ChiCycle

ChiCycle feedback on the B2144 Oving Road, WSCC Walking and Cycling Proposals.

6th November 2022

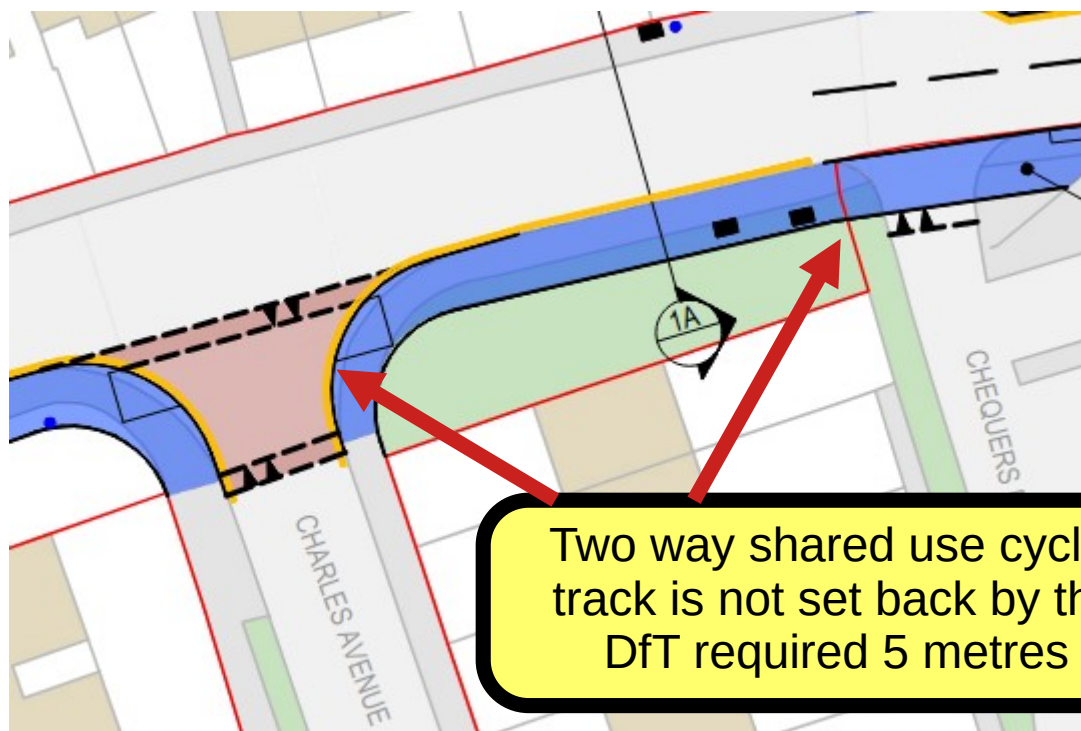
2.5) LTN1/20 section 10.5 gives cycle design guidance on priority junctions. Option1 B2144 Oving Road shared use pavement proposals rely on routing two-way cycle traffic over the mouths of junctions while maintaining priority over traffic. However LTN 1/20 paragraph 10.5.24 states **this arrangement is suitable for one way cycle traffic only!**:

10.5.24 This approach is suitable for one way tracks travelling in the same direction as the adjacent traffic lane, as shown in figure 10.17. Drivers must give way to cyclists when leaving the side road, but there is no priority for cyclists over traffic turning in.

The image clip below from Option1 drawings shows no attempt to set the priority cycle crossing back by the DfT required 5 metre minimum despite having available space to do this.

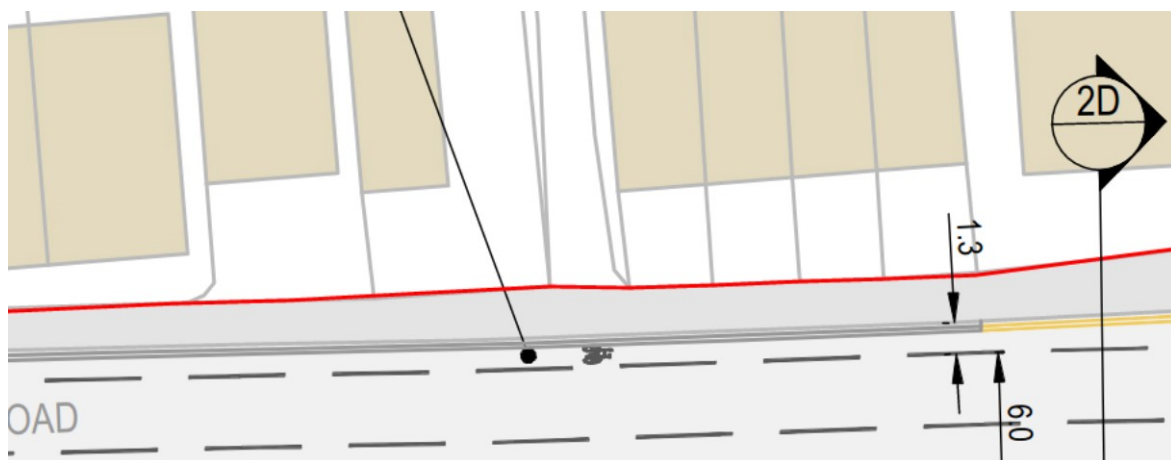
2.8) Option 1 B2144 Oving Road proposals show a ludicrously narrow shared use pavement on the A259 Whyke road. It is labelled as only 2.2 metres on the plans.

LTN1/20 Table 5-3 (Additional width at fixed objects) **requires additional width of 500mm** wherever a cycle track (including shared use) is bounded by features (such as brick walls) that are greater than 600mm in height.

The absolute minimum effective width for a cycle track (even if it is not shared use) is 2 metres and since the A259 pavement is bounded by walls exceeding 600mm high, to maintain the **absolute minimum** effective width, the shared pavement must be at least 2.5 metres wide! What is being offered is only 2.2 metres wide!

A short length of 2.5 meter wide narrow shared use pavement might be marginally acceptable in a quiet rural location but is wholly substandard for a busy urban location such as Whyke Rd. The proposed Option1 shared pavement along the A259 pavement fails to meet even the very lowest of standards. It is not safe, it will not encourage active travel, and it will be a waste of valuable public money.

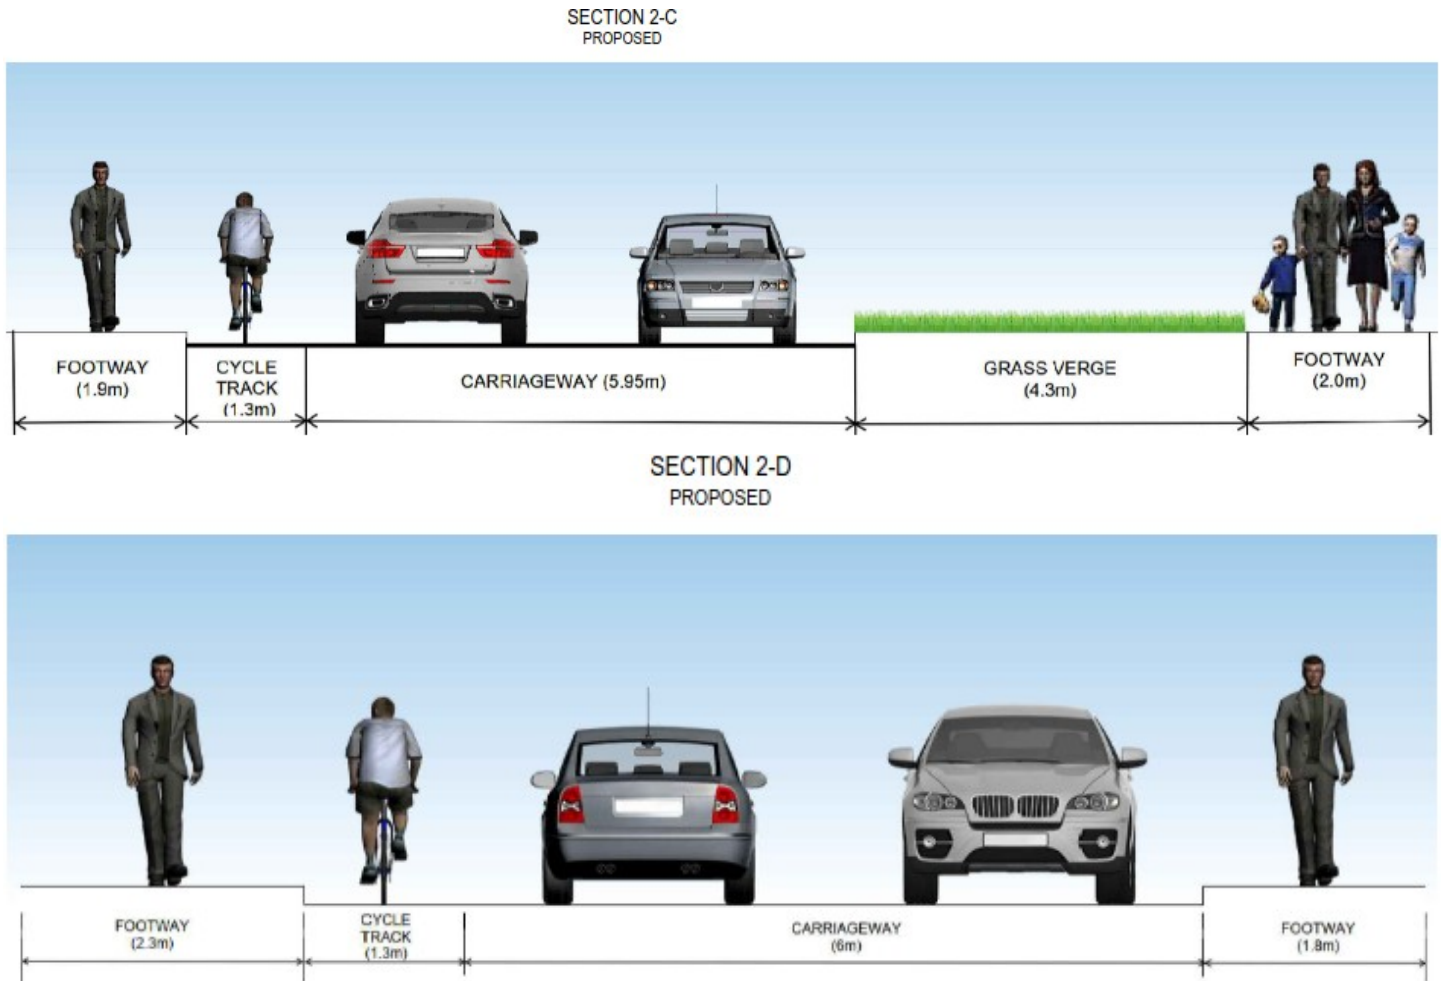
3.2) Option2 offers only occasional short stretches of narrow advisory cycle lanes. The the cycle lane's width is **below the DfT absolute minimum!** The clip from the proposed plans below shows a section on the north side of Oving Rd that is only 1.3 metres in width!

6.4.2 The width of cycle lanes should meet the geometric requirements set out in Chapter 5. A **2.0m wide** lane allows space for overtaking within the lane and **is the minimum recommended width.**

6.4.3 **Cycle Lanes less than 1.5m wide should not normally be used as they will exclude the use of the facility by larger cycles and are therefore not inclusive. They can also encourage 'close-passing' of cyclists by motorists, who tend to judge their road position with reference to the nearside marking.**

Despite DfT warnings that cycle lanes below absolute minimum widths create hazards for cyclists, two of the sections shown in Option2 plans propose narrower cycle lanes. As can be seen below, Section 2-C and Section 2-D show cycle lane widths of only 1.3 metres. The DfT **absolute minimum** for a cycle lane is 1.5 metres at constraints. Both sections showing narrow cycle lanes are shown below:

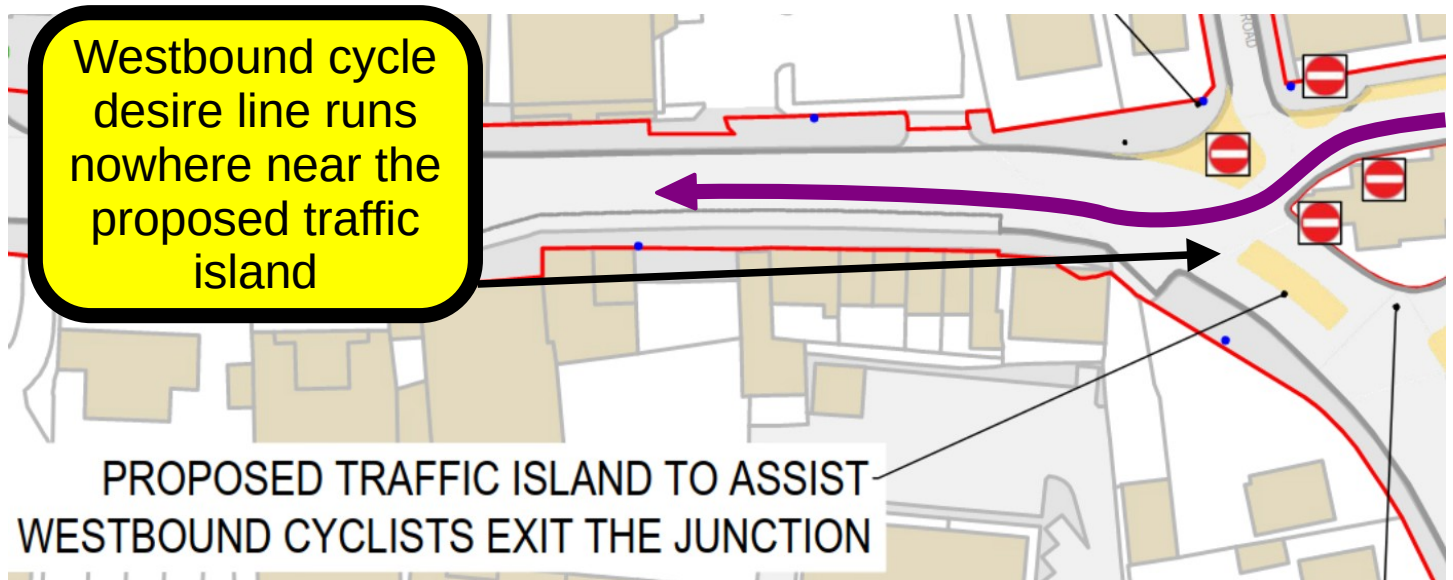
3.4) Text accompanying the Option2 proposals states there will be “A traffic island on the junction with the A259 Whyke Road to assist westbound cyclists in exiting the junction”.

Insufficient detail is given to make a full assessment of this intervention, but the island’s placement is well away from the desire line for cyclists and it will therefore provide no benefit. The diagram below illustrates the issue.
